Attachment 3
Proposed Changes to Technical
Specifications for Reload 6

Proposed Changes

The proposed changes involve Pilgrim Nuclear Power Station Technical Specifications, Appendix A, Sections 3.11 and 5.0, Reactor Fuel Assembly and Major Design Features, respectively. Specifically, the proposed changes are shown on attached Technical Specification Pages 205B-2, 205E-4, 205E-5, 205E-6, and 206m and are described below.

FIGURE 3.11-4
MAXIMUM AVERAGE PLANAR LINEAR HEAT GENERATION RATE
VERSUS
PLANAR AVERAGE EXPOSURE

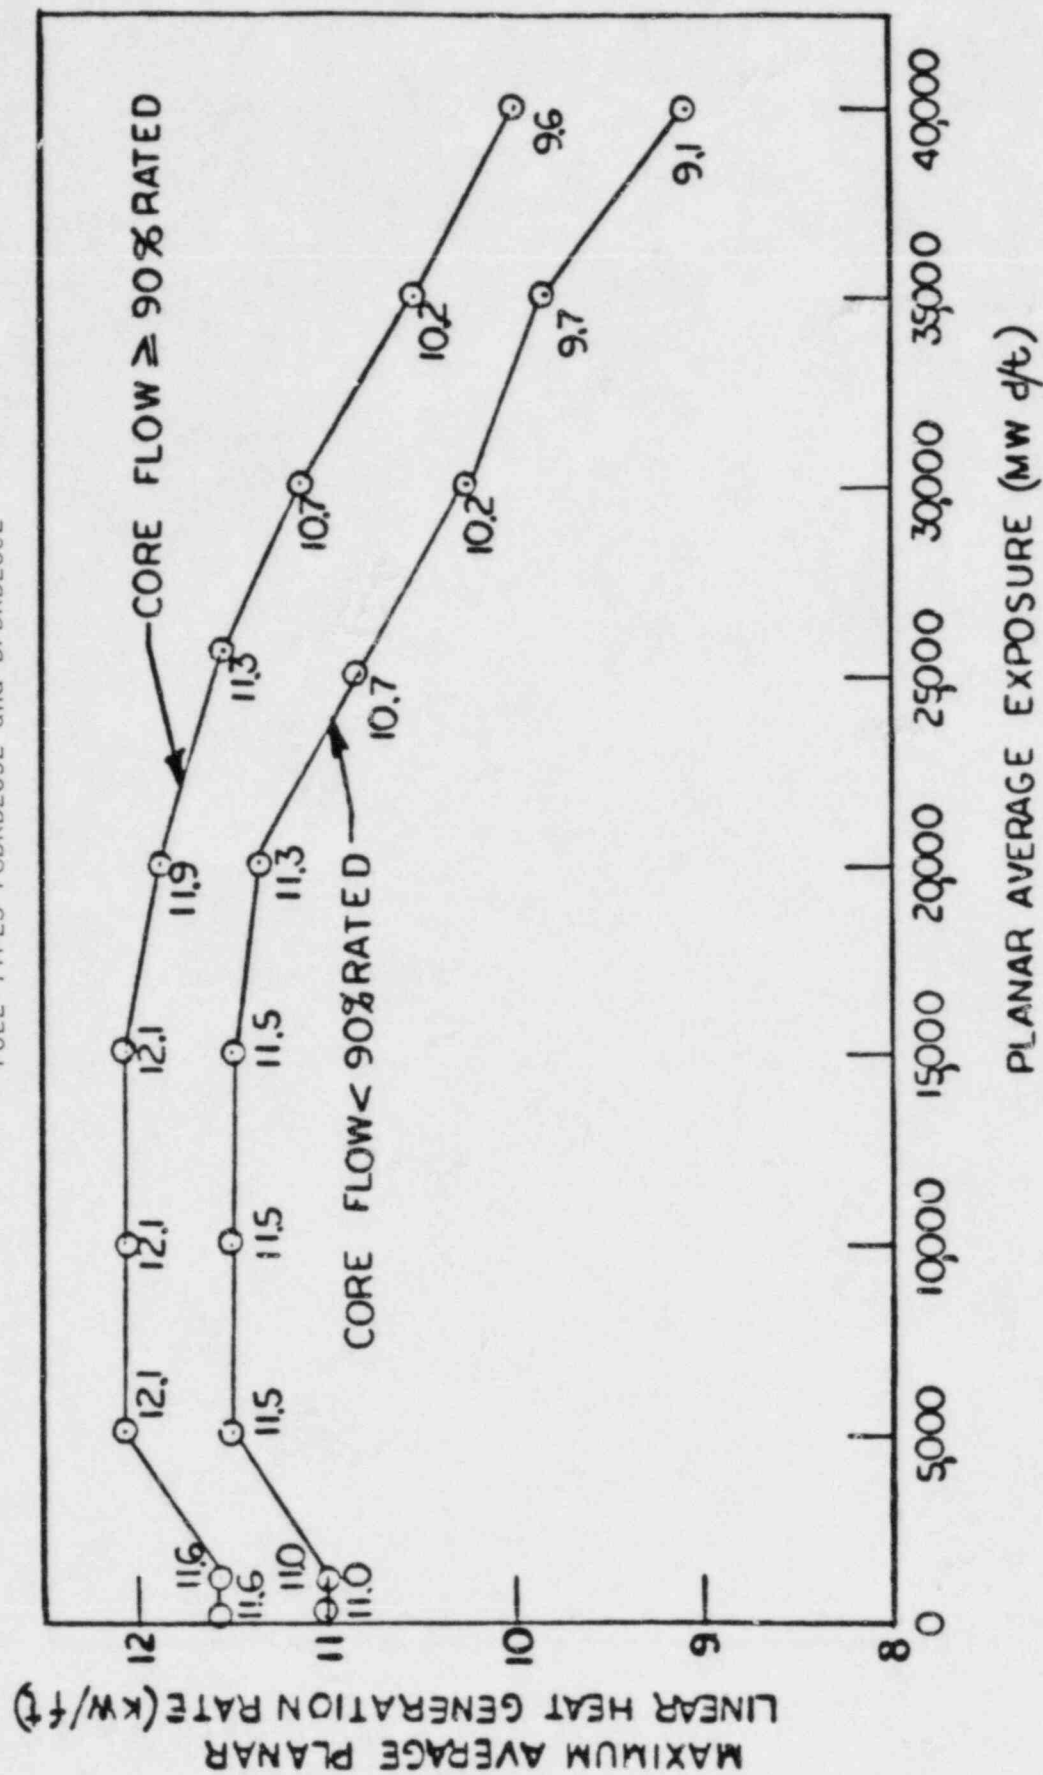
1. The operating limit minimum critical power ratio (MCPR) values are proposed to be changed as shown on the attached Technical Specification Table 3.11-1 (Page 205B-2). The proposed changes to this table include references to the barrier-type fuel that will be used in Reload 6 at Pilgrim.
2. The maximum average planar linear heat generation rate (MAPLHGR) versus planar average exposure curves in Technical Specification Figures 3.11-4, 5, and 6 are proposed to be changed to reference the barrier-type fuel that will be used in Reload 6 at Pilgrim. These figures are to be revised as shown on attached Technical Specification Pages 205E-4, 205E-5, and 205E-6.
3. The major design features of the reactor are proposed to be changed as shown on attached Technical Specification Page 206m to reference the barrier-type fuel that will be used in Reload 6 at Pilgrim.
